ElectraNet
Att: Steve Masters, Chief Executive Officer
via consultation@electranet.com.au

06 November 2018

South Australian Energy Transformation Project Assessment Draft Report (PADR) – Supplementary Submission

Figure 4 – NPV Results to 2033 with full depreciation and 30% lower network support payments for Option A

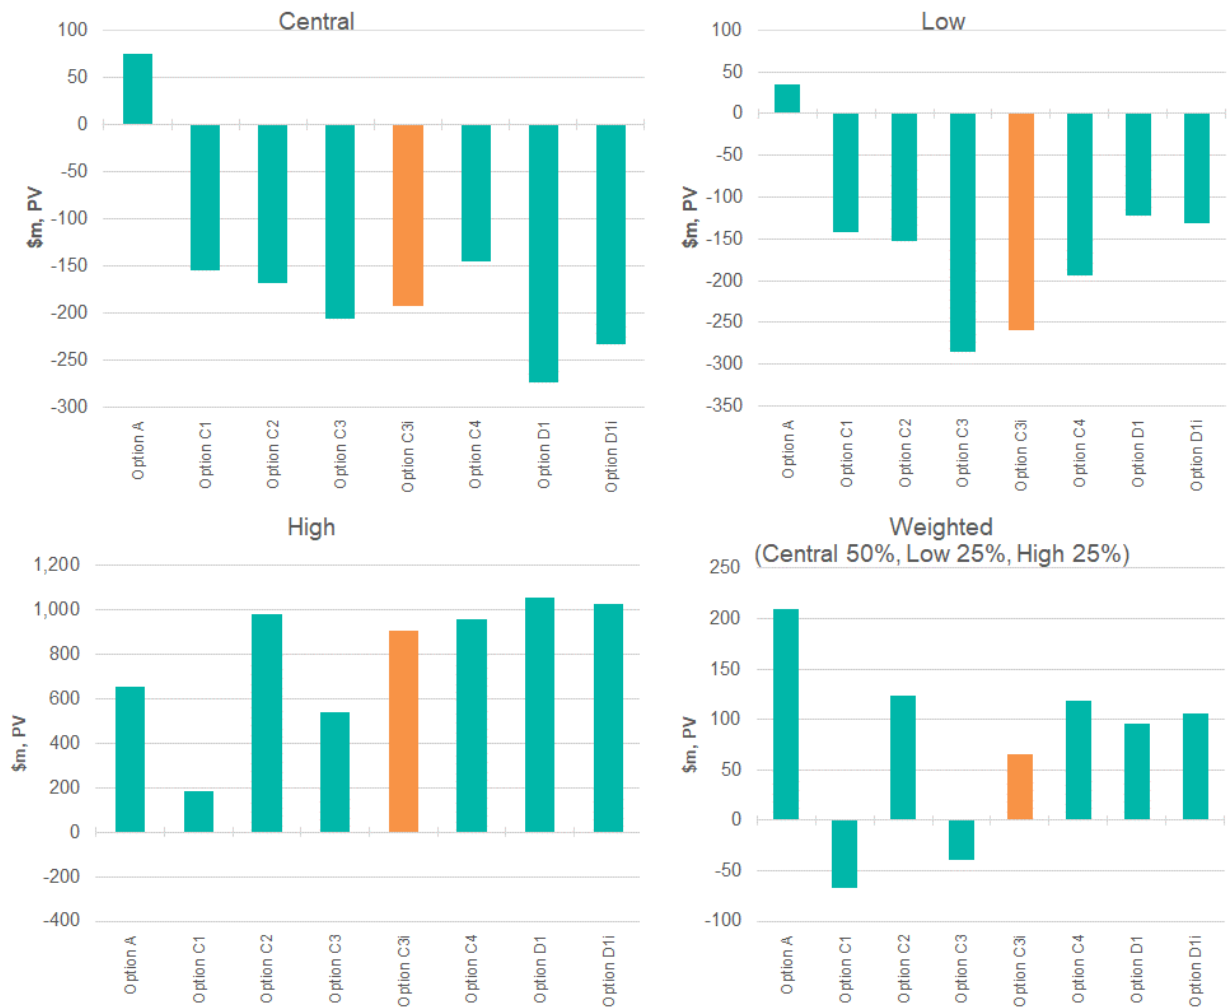
- 'Time horizon' for each scenario to 15 years; AND
- 'asset life' to no more than 15 years; AND
- testing the sensitivity of the results by lowering the costs of Option A by 30% (the lower bound of the ElectraNet sensitivity analysis).

As can be seen, Option A re-emerges as the preferred option in this case – highlighting the sensitivity of the non-interconnector options to the assumptions made with respect to annualised network support payments for this option.
